PROJ. NO.: G25003-01
SUBJECT: Addendum No. 2
Court Renovation
City of Fort Oglethorpe, Georgia

**ADDENDUM NO. 2
COURTS RENOVATION
CITY OF FORT OGLETHORPE, GEORGIA
CTI PROJECT NO. G25003-01**

Fort Oglethorpe Courts Renovation

Architectural Floor and Ceiling Plans

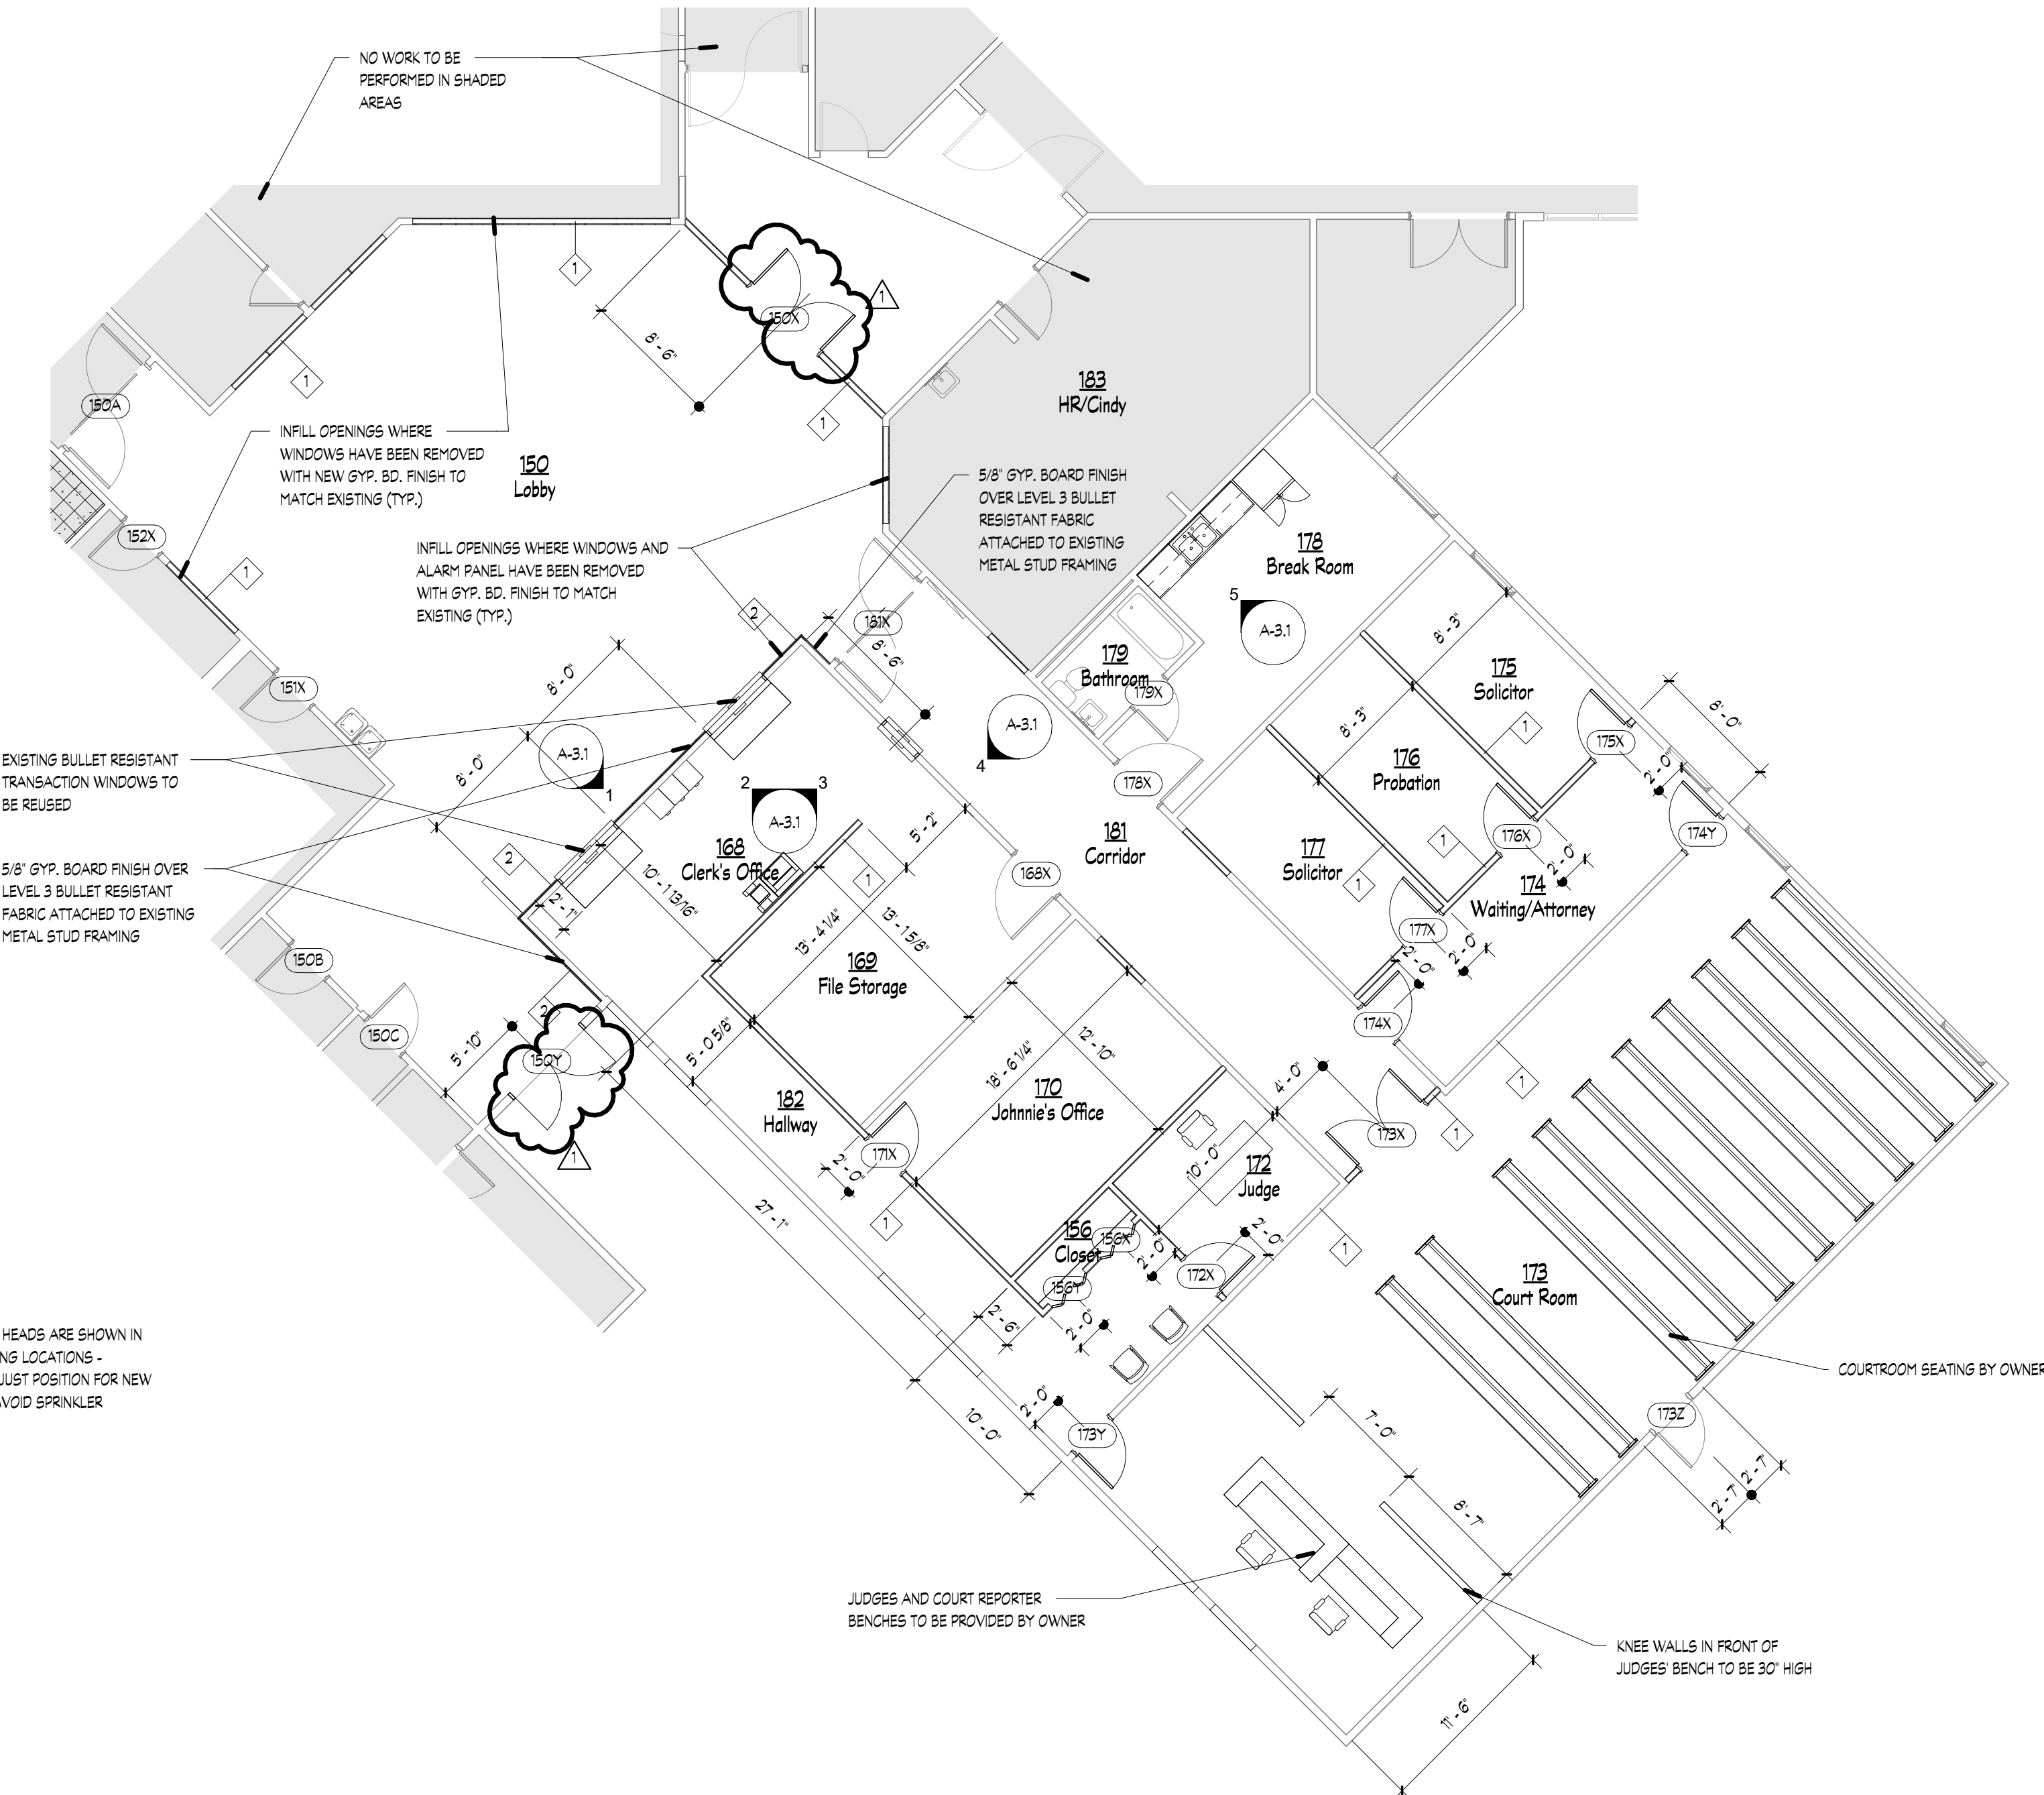
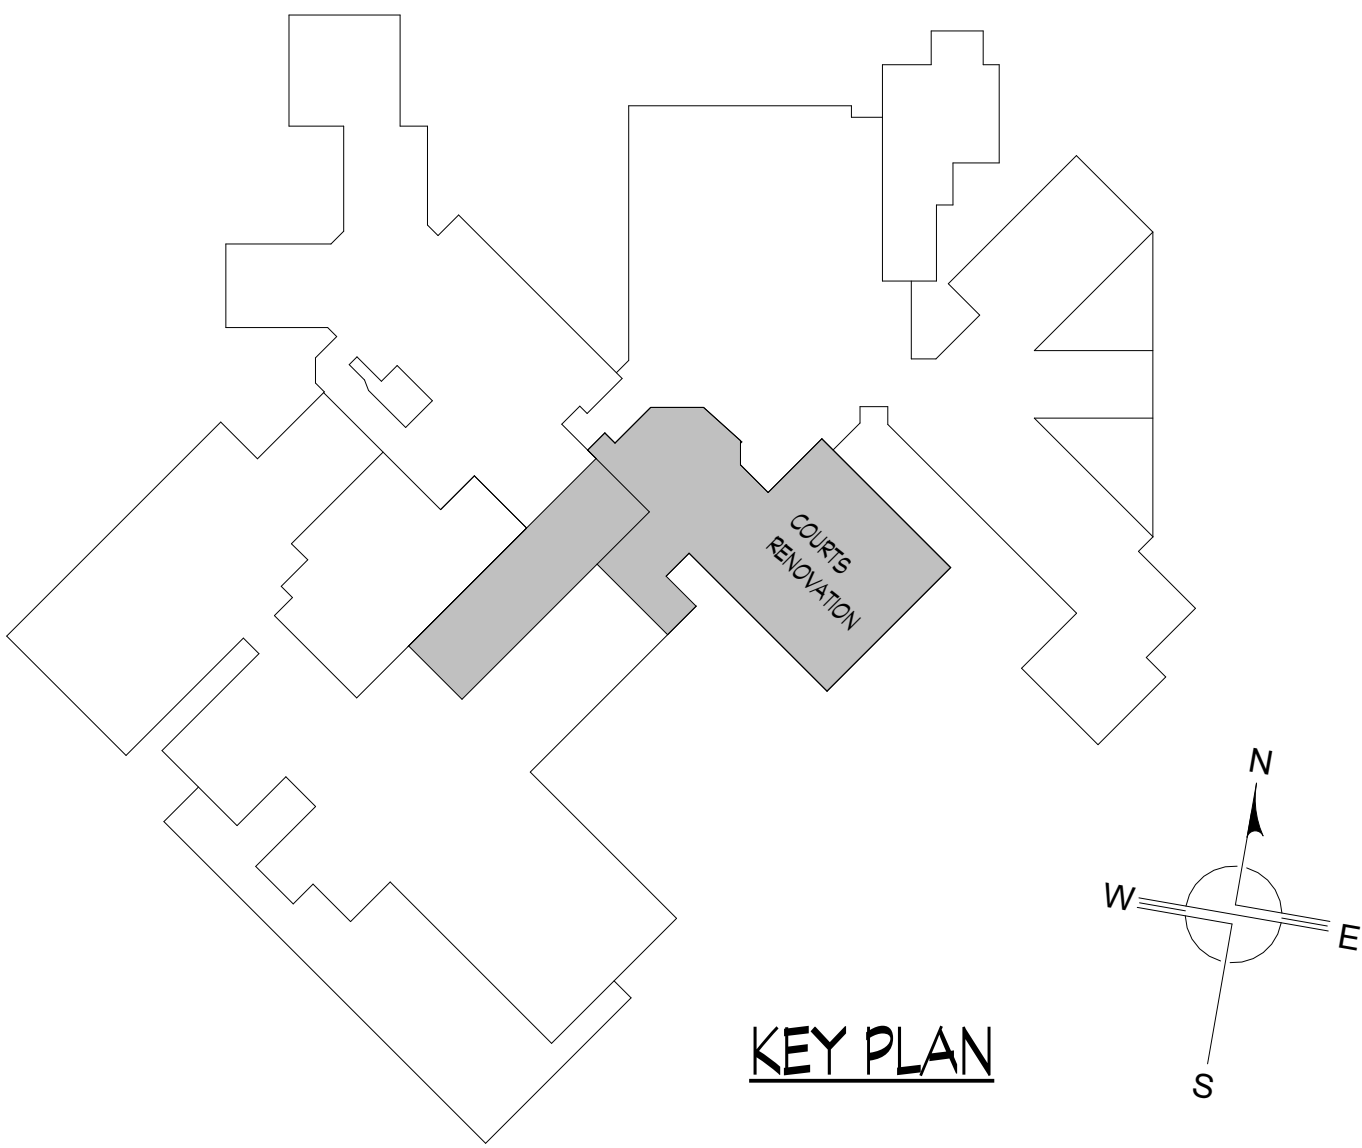
Revision Schedule		
Rev. #	Rev. Date	Revision Description
1	07/24/26	Door Change

Door and Hardware
Schedule and Details

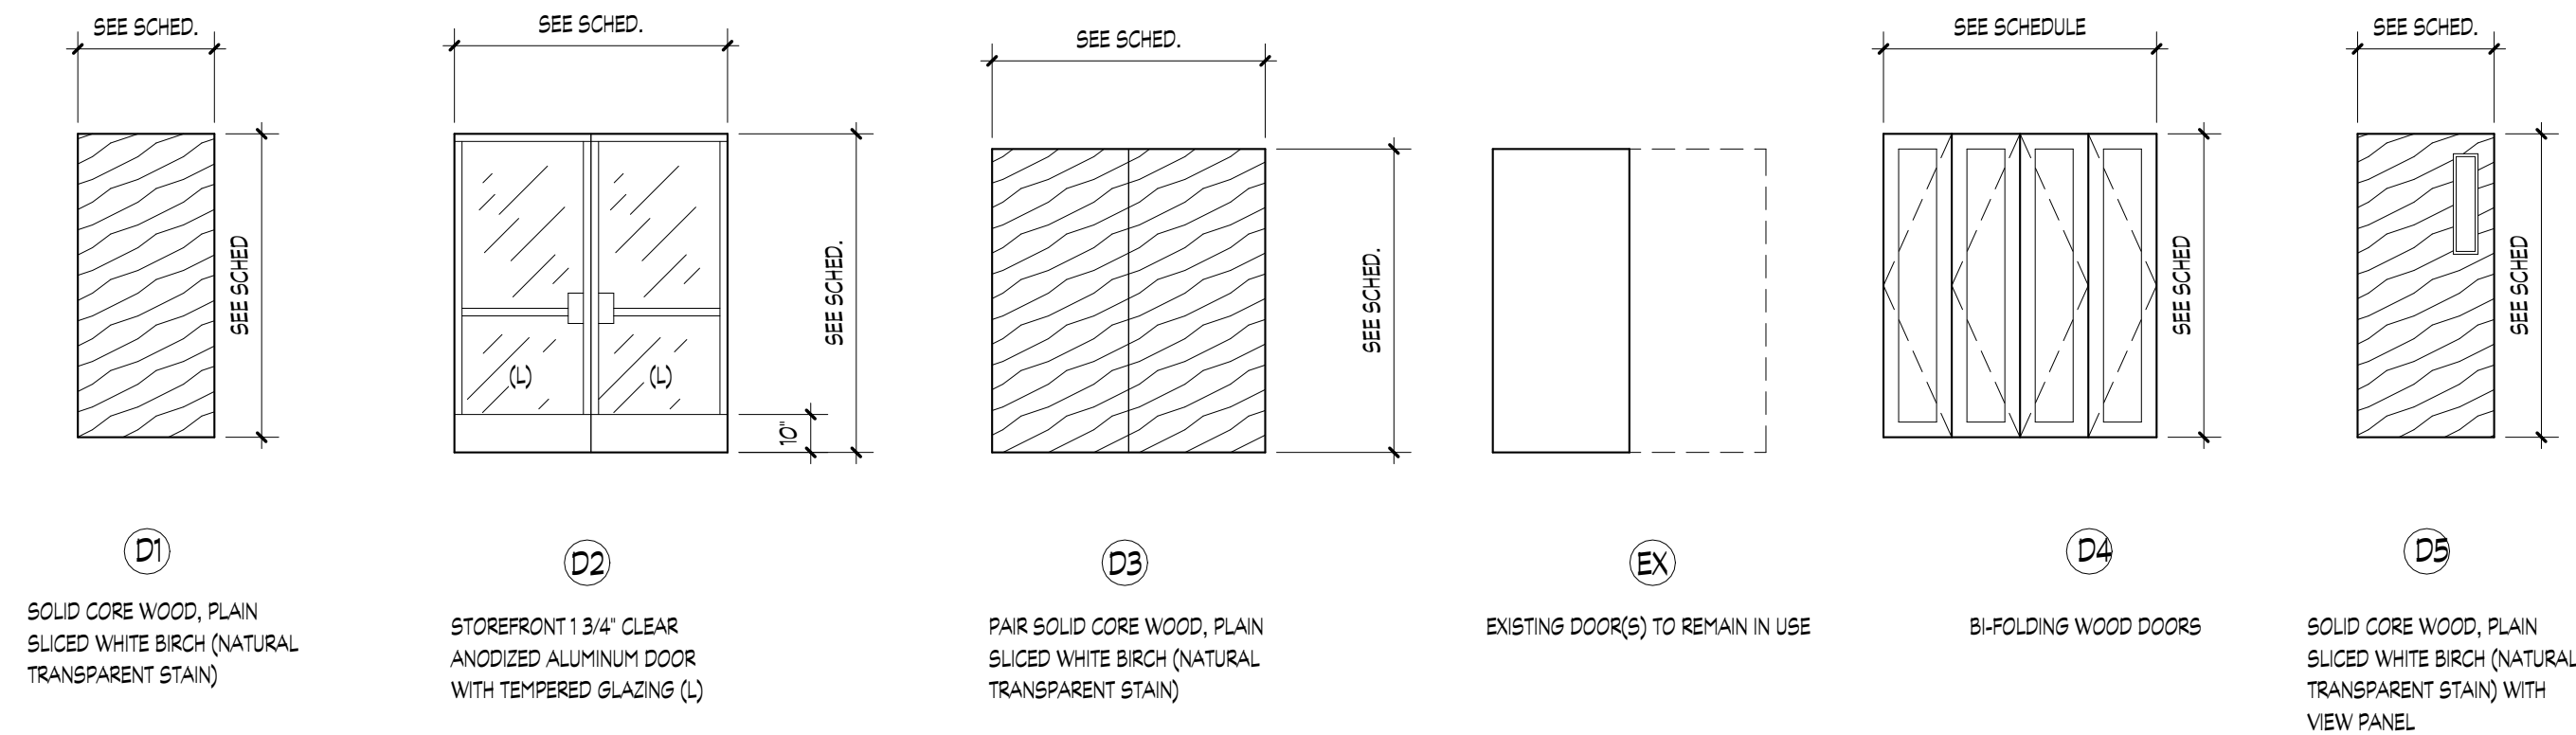
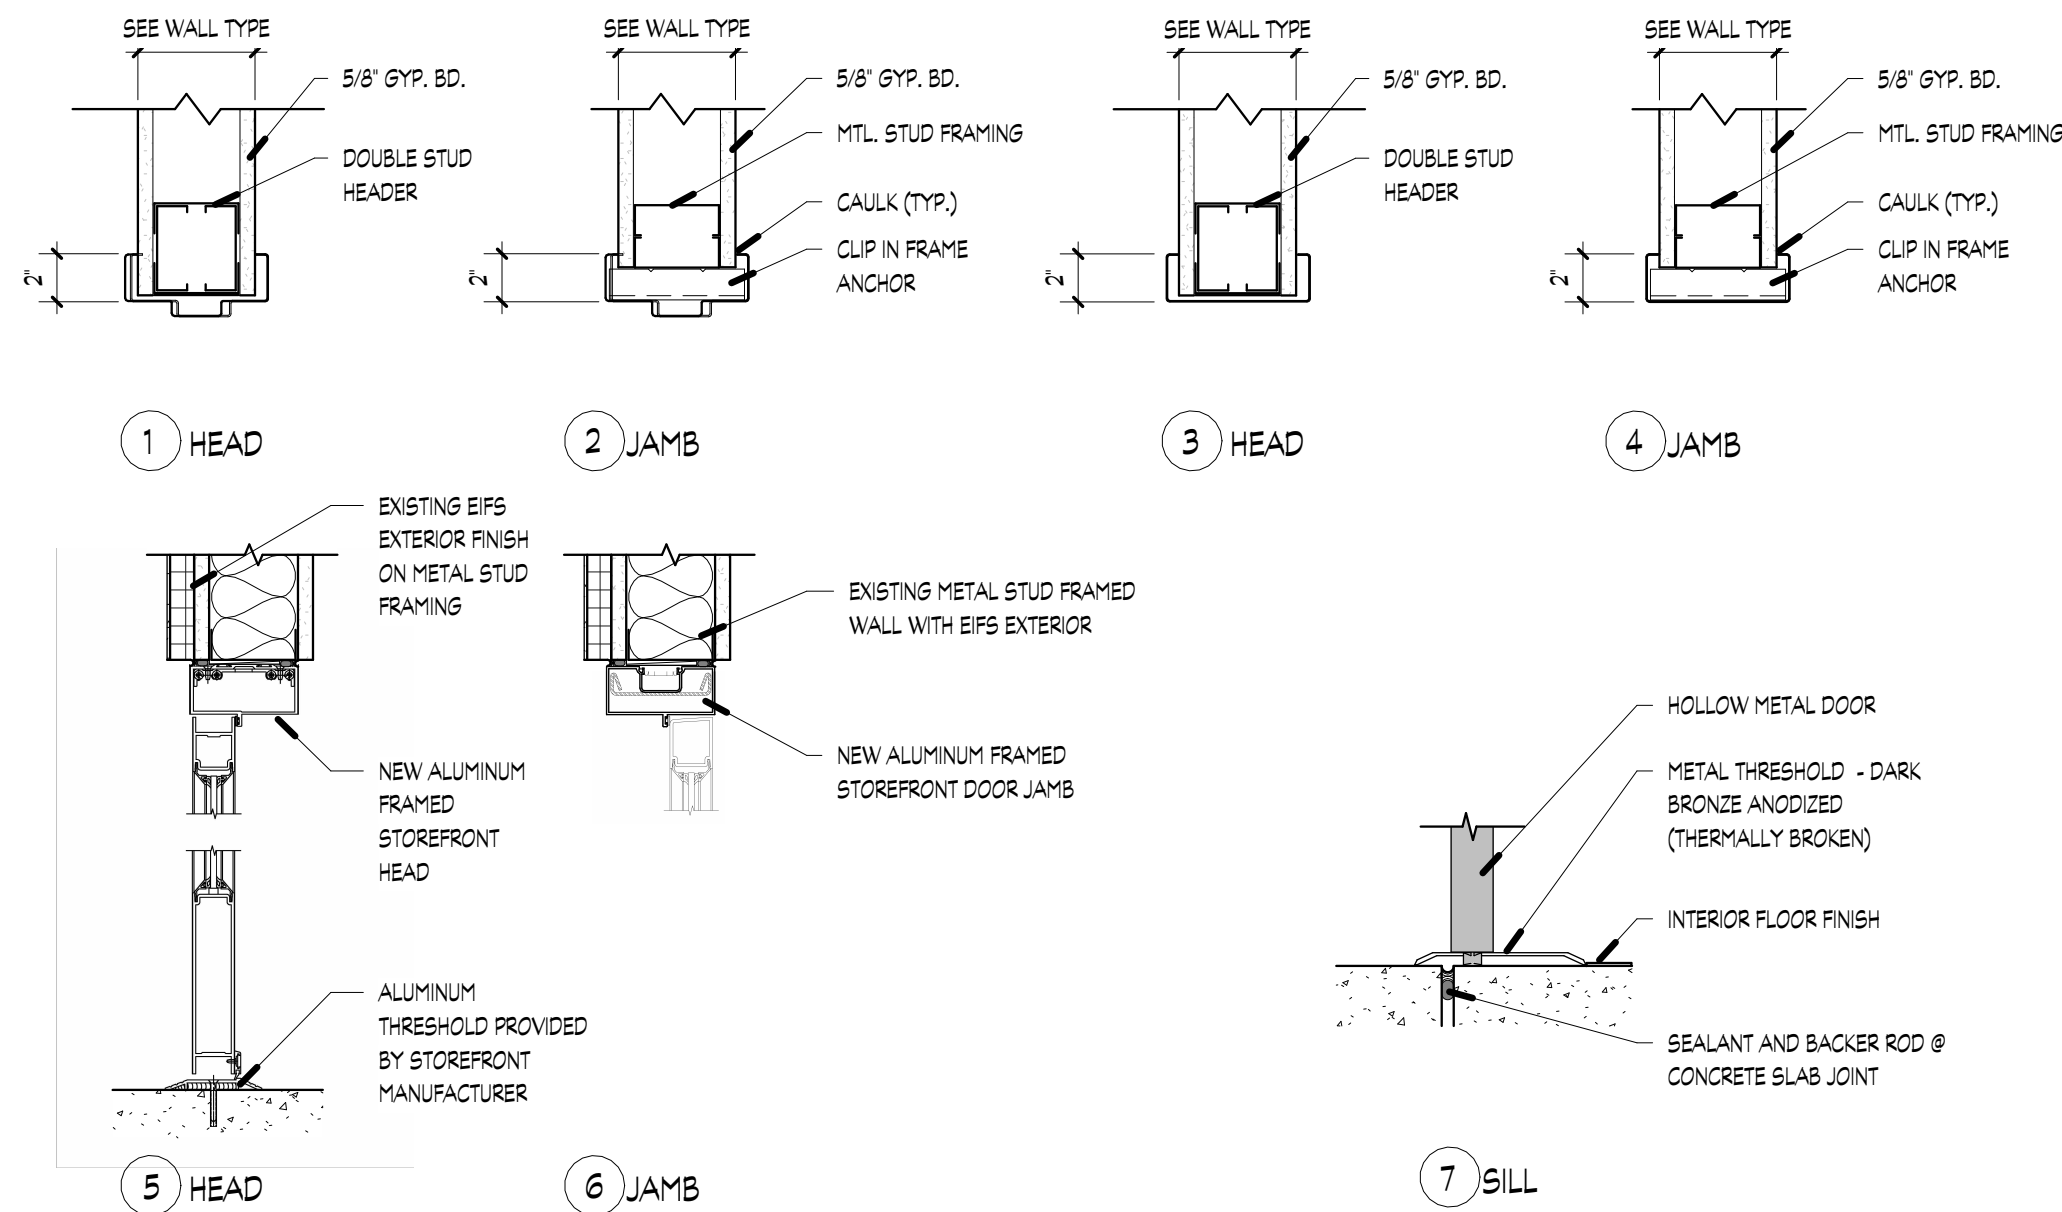
Revision Schedule		
Rev. #	Rev. Date	Revision Description
1	07/24/26	Door Change
